RE: **Lot 18 Block 5 Unit 18 Volcano Cliffs SAD 228**
6624 Sujeto NW
Grading and Drainage Plan
Engineers Stamp Date 7/20/17 (D10D003K18)

RE: **Lot 18 Block 5 Unit 18 Volcano Cliffs SAD 228**
6624 Sujeto NW
Grading and Drainage Plan
Engineers Stamp Date 7/18/17 (D10D003K18)

Based upon the information provided in your submittal received 7/19/17, this plan cannot be approved for Grading Permit until the following comments are addressed.

TURNED BLOCKS

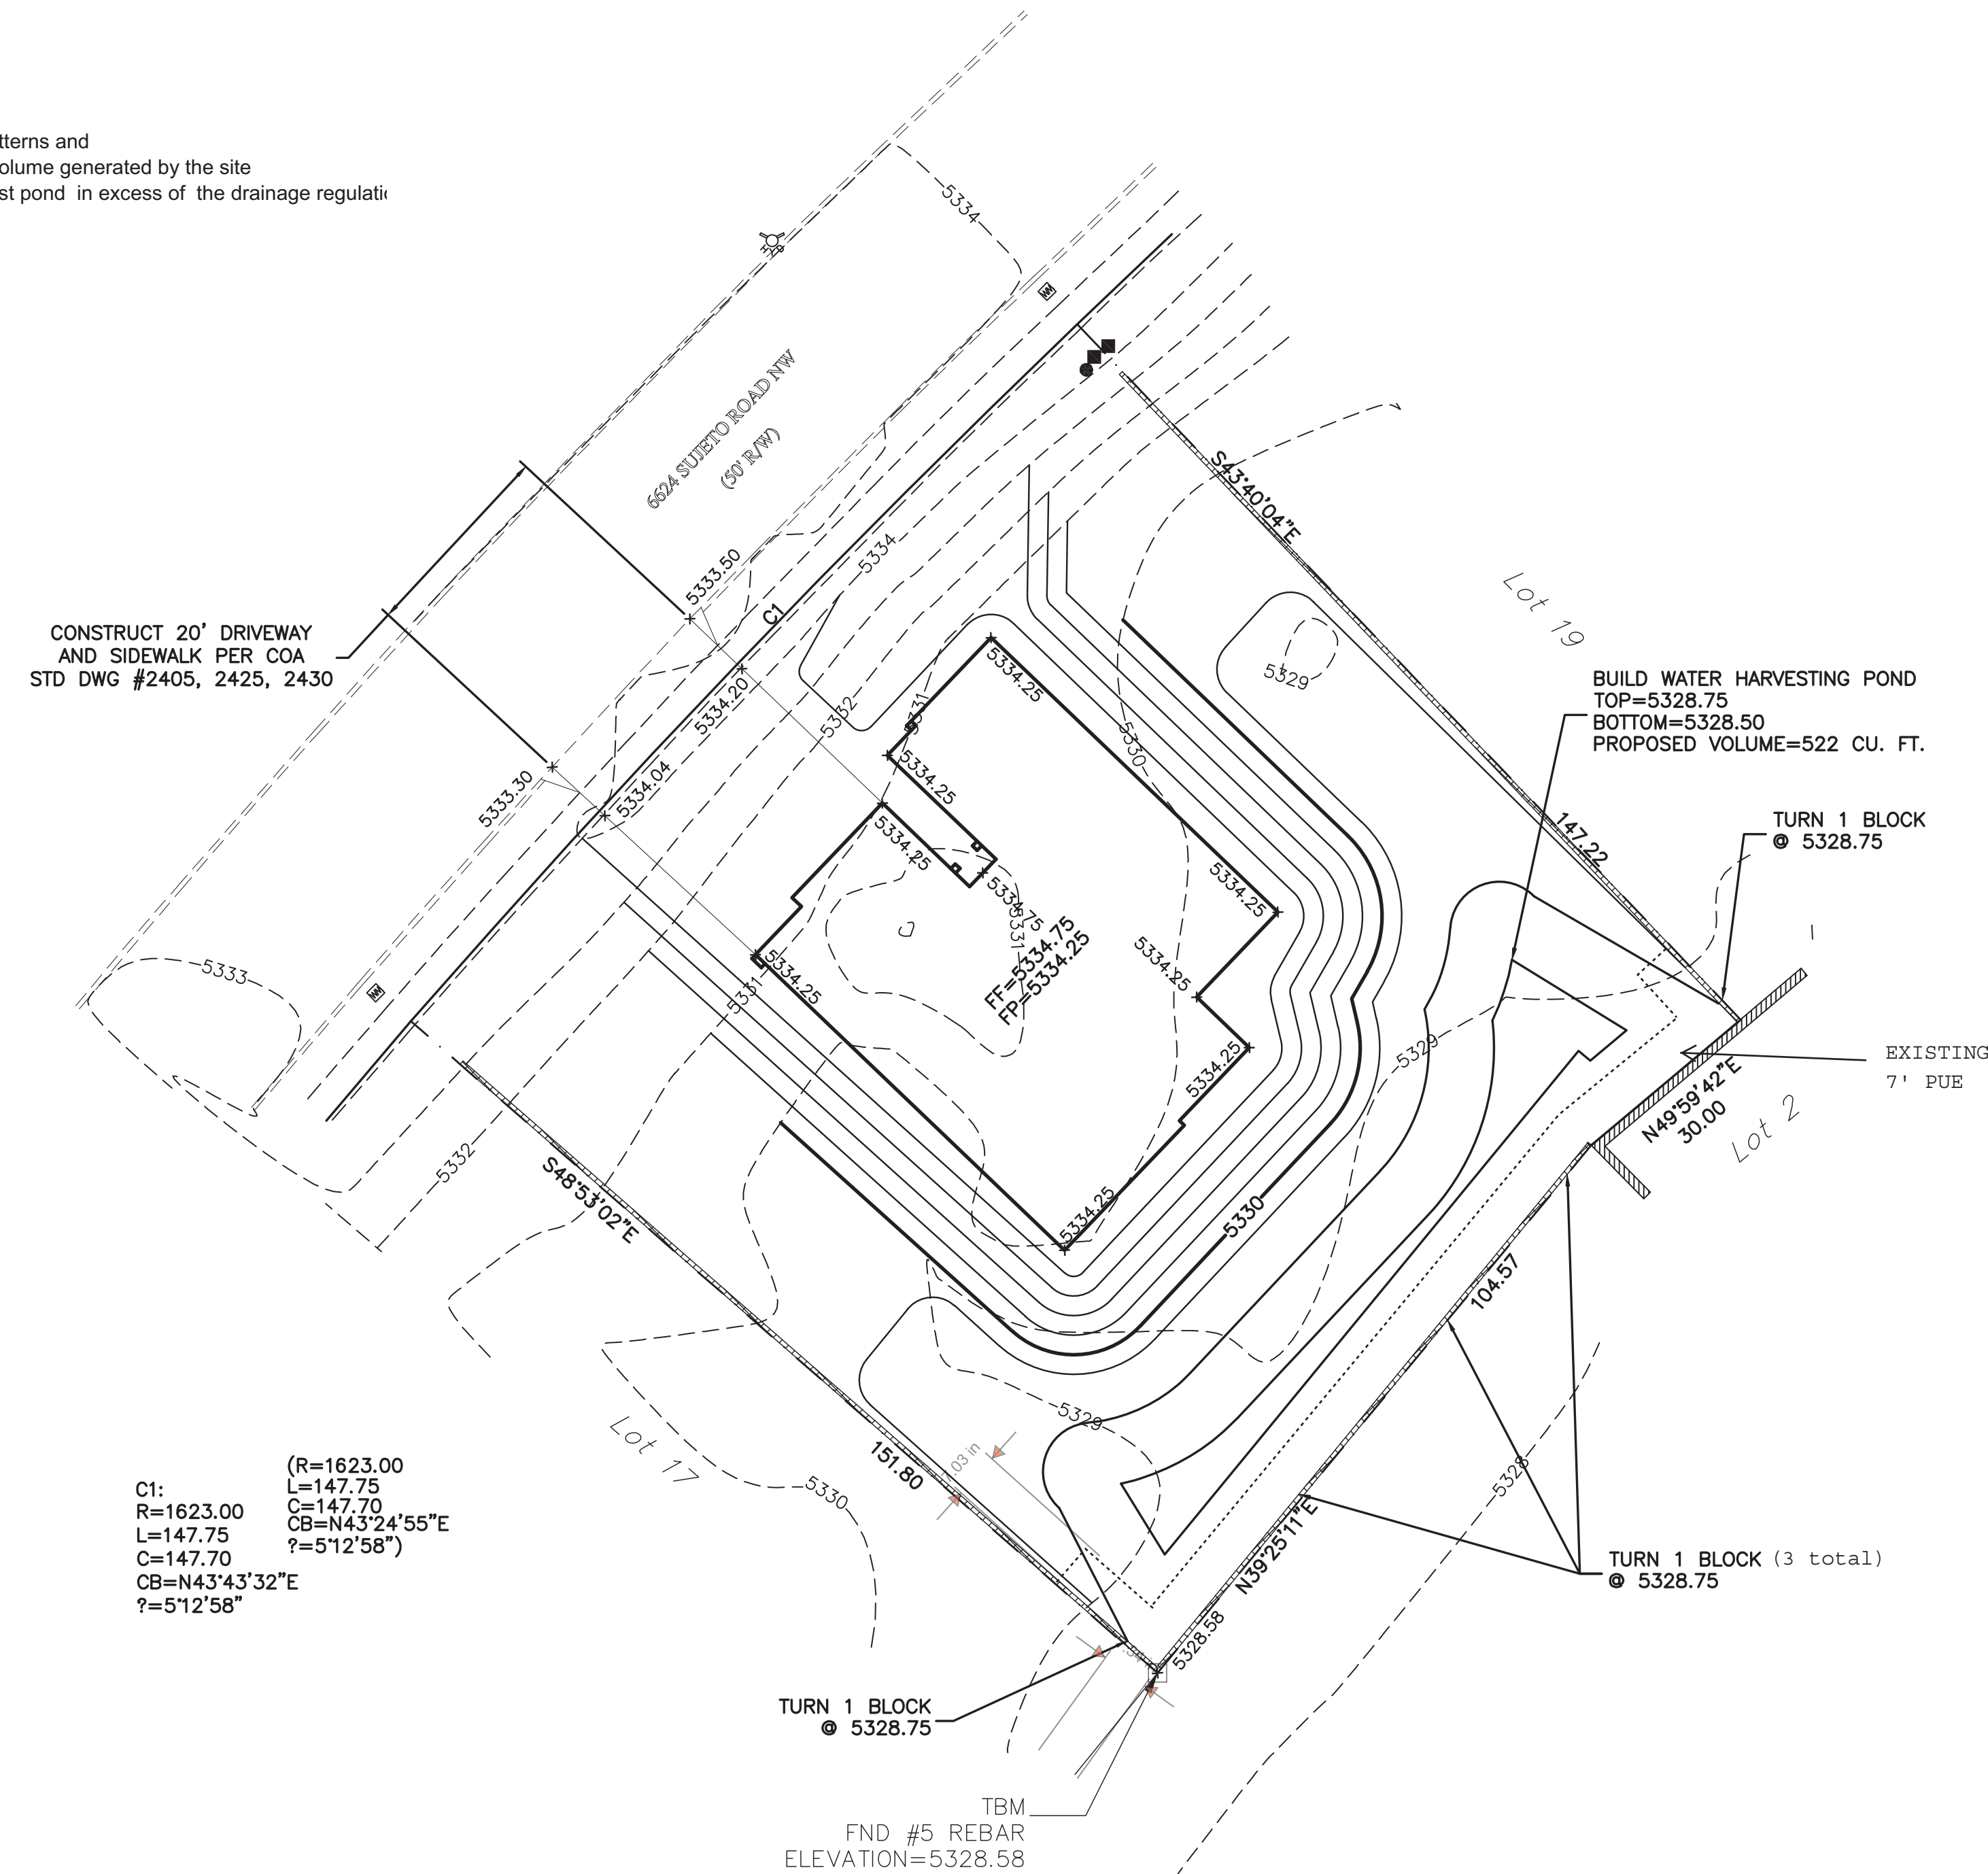
- Provide calculations for the openings in the walls. **we have added the calculations**
- Show the 7 foot P.U.E. **We have shown the PUE**

Each opening is 6"x6"
Each block has two openings
Each opening has .52 cfs capacity
Each turned block has a 1.04 cfs capacity
